February 21, 2013

File No. LDA12-0124

RE: Tentative plan of subdivision to create one (1) medium density residential lot from SE 23-51-25-4, located west of 141 Street SW and north of 28 Avenue SW; **HAYS RIDGE**

SUBDIVISION CONDITIONS OF APPROVAL MAP

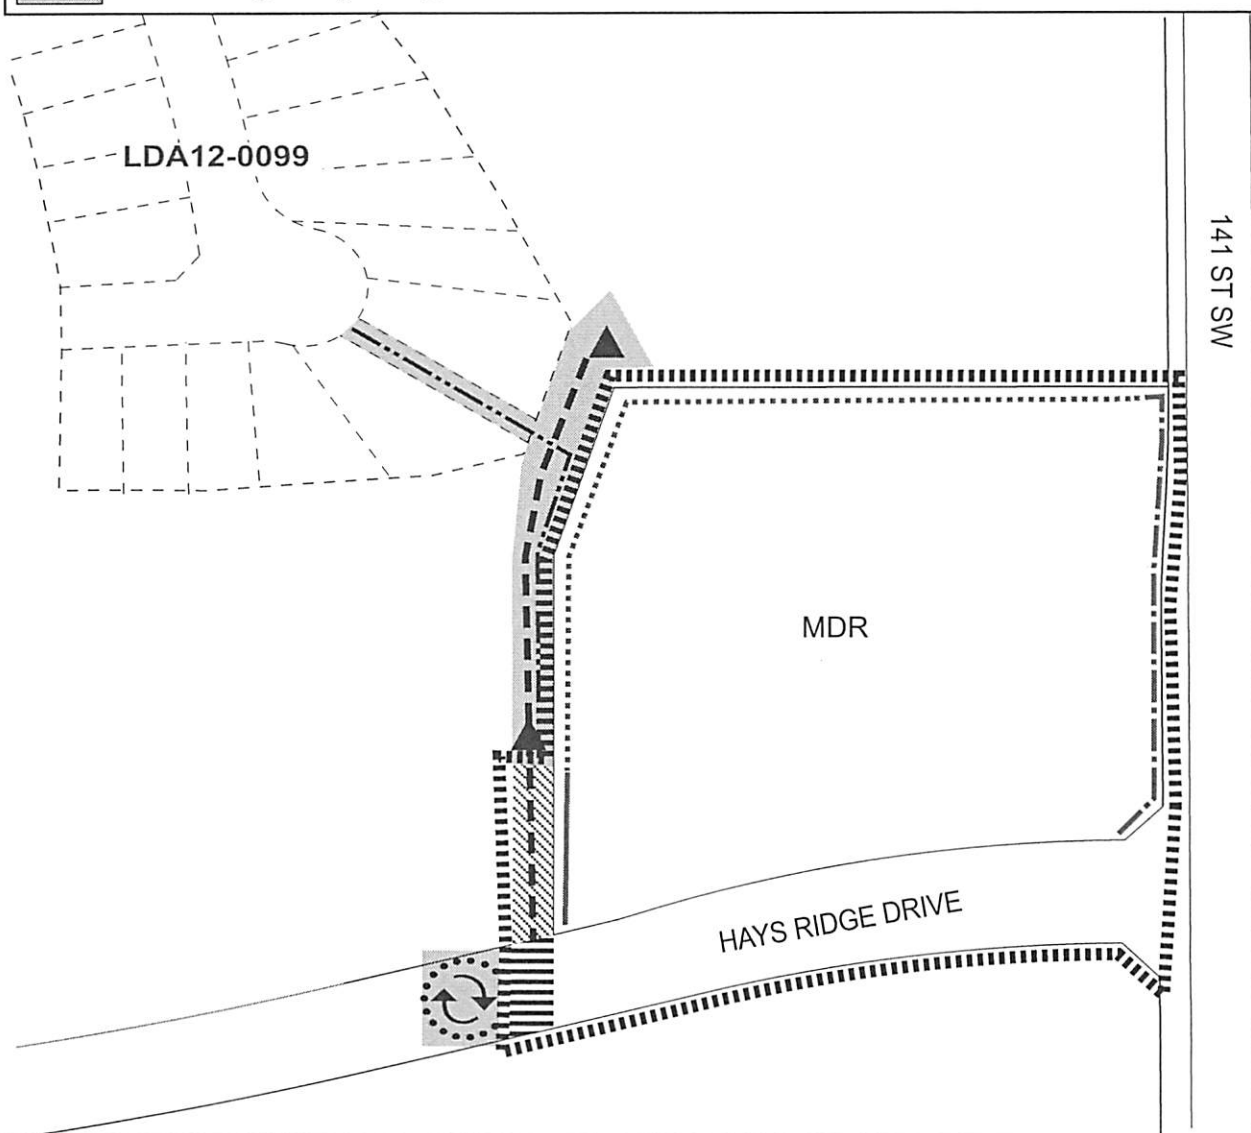
5. that the owner register the walkway as 10 m road right-of-way, as shown on the "Conditions of Approval" map, Enclosure I; and
6. that the owner pay all outstanding property taxes prior to the endorsement of the plan of subdivision.

8. that the engineering drawings include a 12 m radius temporary turnaround with bollards or mini-barriers, prior to CCC, or to the satisfaction of Transportation Services, as shown on the "Conditions of Approval" map, Enclosure I;

9. that the engineering drawings include offsite water main connections to provide water main looping, to the satisfaction of EPCOR Water Services, as shown on the "Conditions of Approval" map Enclosure I;

10. that the owner construct a zebra marked crosswalk with curb ramps and pedestrian signage, as shown on the "Conditions of Approval" map, Enclosure I;

11. that the owner construct a 1.5 m concrete sidewalk with lighting and bollards, as shown on the "Conditions of Approval" map, Enclosure I;
12. that the engineering drawings include a 1.5 m concrete sidewalk with lighting and bollards, as shown on the "Conditions of Approval" map, Enclosure I;

13. that the engineering drawings include signage and design elements to separate the golf course path from the sidewalk within the road right-of-way, as shown on the "Conditions of Approval" map, Enclosure I;

14. that the owner construct all fences wholly within private property lines, to the satisfaction of the Transportation Services and Sustainable Development, as shown on the "Conditions of Approval" map, Enclosure I; and
